GRADING & DRAINAGE PLAN

DATE	REVISION	LOT 5-A, BLOCK B, PARKLAND HILLS
6/9/98	Revised P&ID	STELLA BLANCO - THE SHADY LADY STORE
	Added P&ID	
	Added P&ID	
	Added P&ID	
	Added P&ID	
DESIGNED BY: PWC	DRAWN BY: CCE	JOB No: PLMPT_STD
CHECKED BY: PWC	DATE: 3/27/98	FILE No: G/D

Grading & Drainage Plan

GRADING & DRAINAGE PLAN

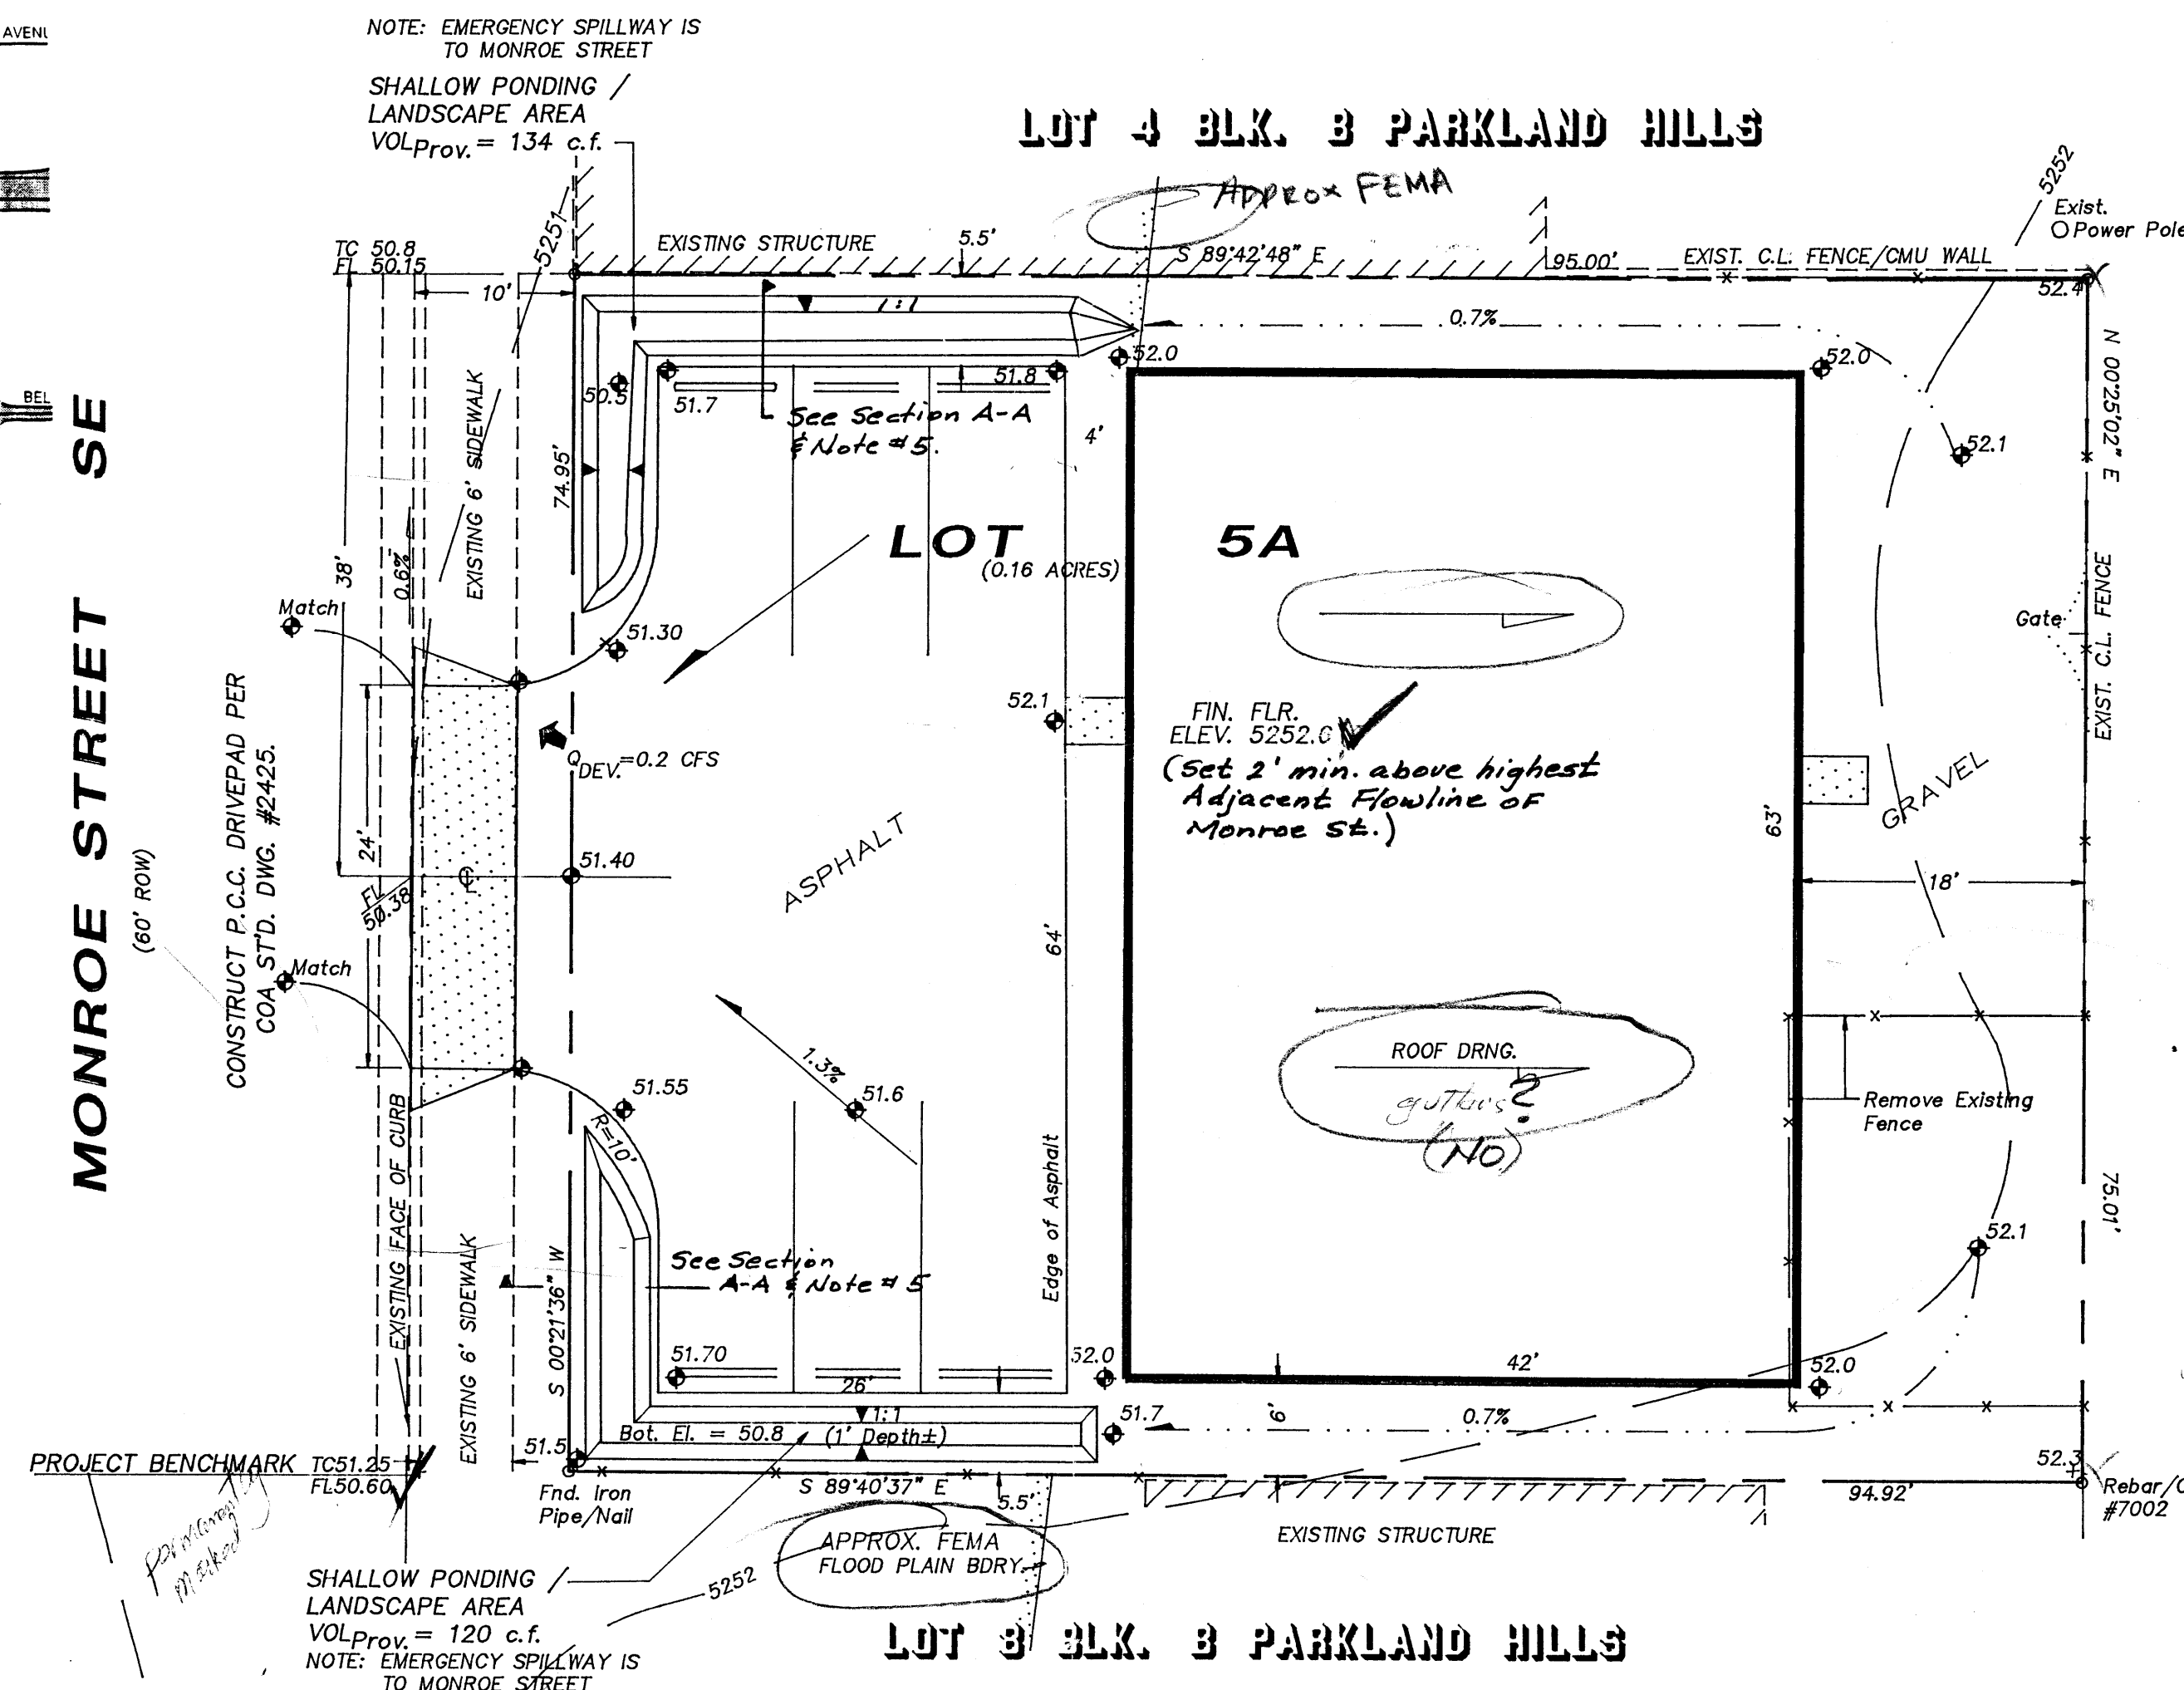
you provide this info

*Ex. 5
G. 60*

existing flows off-site show brown map (alley) (GADP) (proposed)
